DRAINAGE AND TRANSPORTATION INFORMATION SHEET (REV 6/2018)

Project Title: 7924 Victoria NW **Building Permit #:** _____ **Hydrology File #:** _____
DRB#: _____ **EPC#:** _____ **Work Order#:** _____
Legal Description: LOT 16 BLOCK 5 VOLCANO CLIFFS UNIT 2
City Address: 7924 Victoria NW

RE: **Lot 16 Block 5 S.A.D. 227 Unit 2**
7924 Victoria NW
Revised Grading and Drainage Plan
Engineers Stamp Date 7/30/2021 (E10D105)

ENGINEER'S SEAL  7/30/21 DAVID SOULE P.E. #14522	7924 VICTORIA	DRAWN BY: WCVJ
	GRADING AND DRAINAGE PLAN	DATE: 4-27-21
 Rio Grande Engineering 1606 CENTRAL AVENUE SE SUITE 201 ALBUQUERQUE, NM 87106 (505) 872-0999		210210044-LAYOUT-4-27-21
		SHEET #
		JOB # 21021044

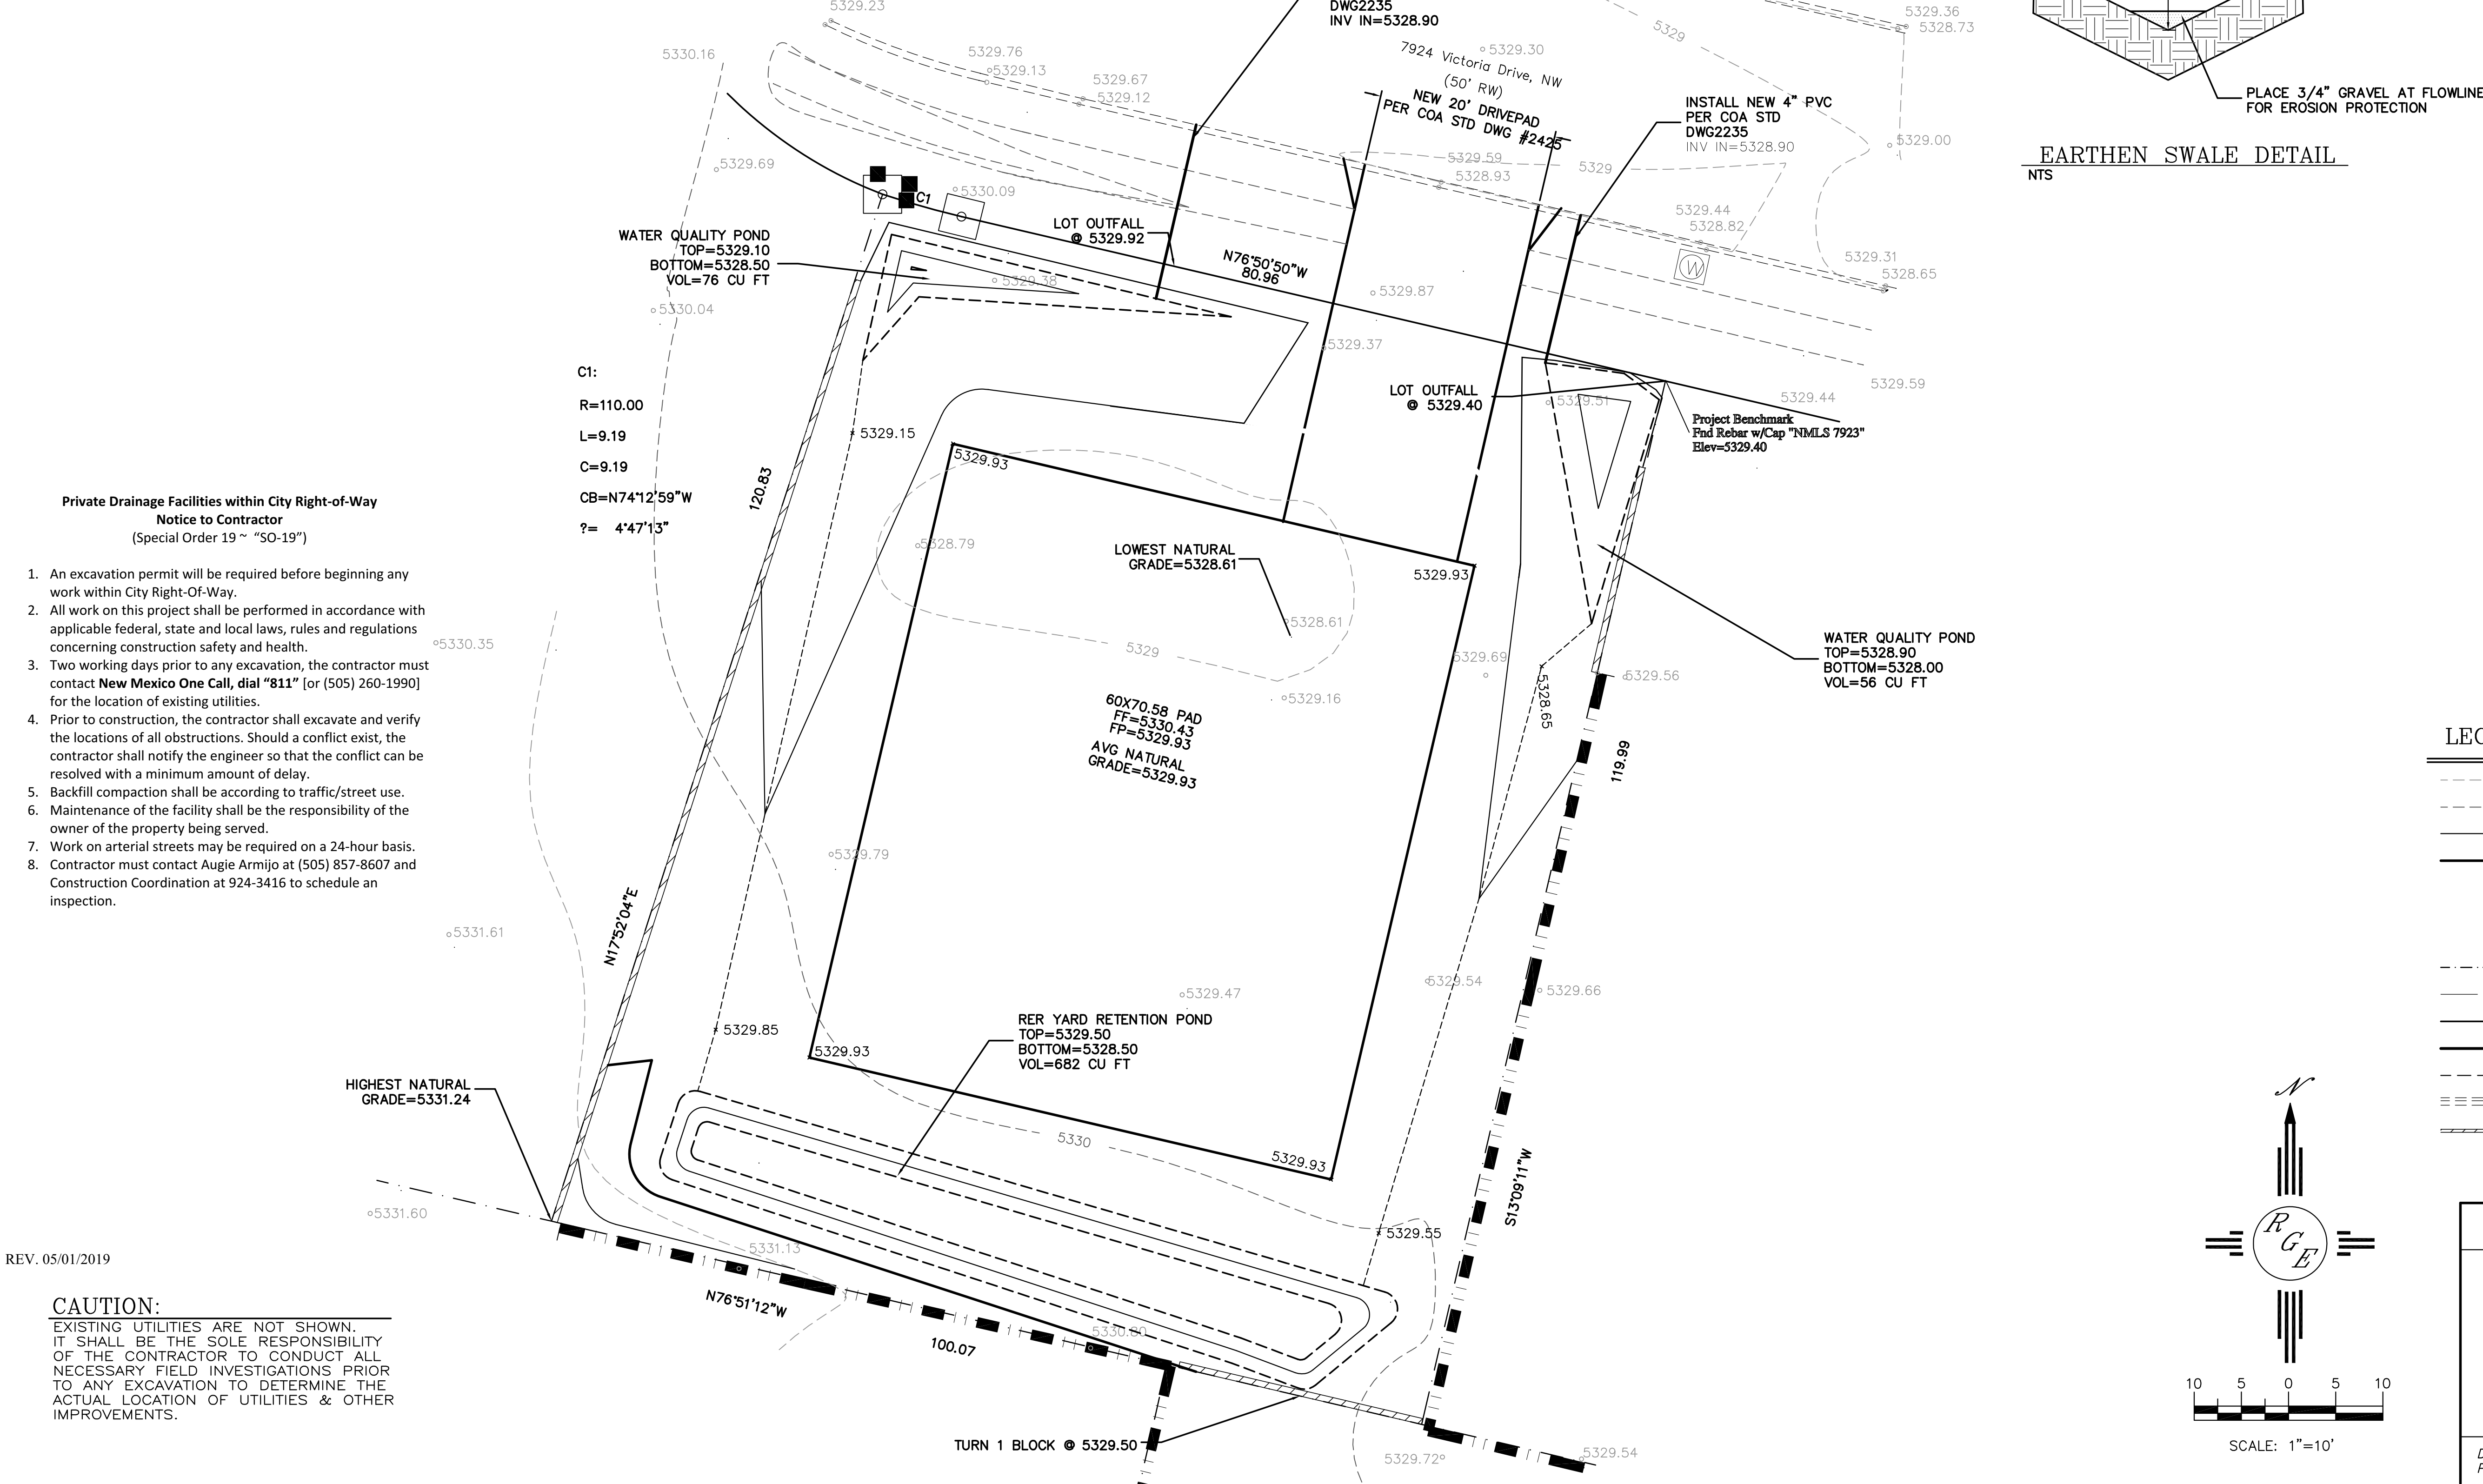
Based upon the information provided in your submittal received 7/30/2021, this plan is approved for Grading Permit. This will now be the plan to use going forward. Please inform the builder/owner to attach a copy of this approved plan and letter into the construction sets in the permitting process prior to sign-off by Hydrology.

Reiterate to the Owner/Contractor that a separate permit for any garden/retaining wall must be obtained, with the approved G&D plan. Advise the owner contractor not to use dirt as a ramp to climb the curb, use lumber or crusher fines for this purpose.
Also, let the owner/contractor know that if a pool is to be added in the future the G&D plan will need to be modified showing the location of the pool and the land treatment differences.

Prior to Building Permit approval, a **Pad Certification** will be required. Inform the contractor/owner not to pile dirt in the street as a ramp to climb the curb. If dirt is found in the street the pad cert. will be denied.

Prior to **Certificate of Occupancy release**, Engineer Certification per the DPM checklist of this plan will be required.
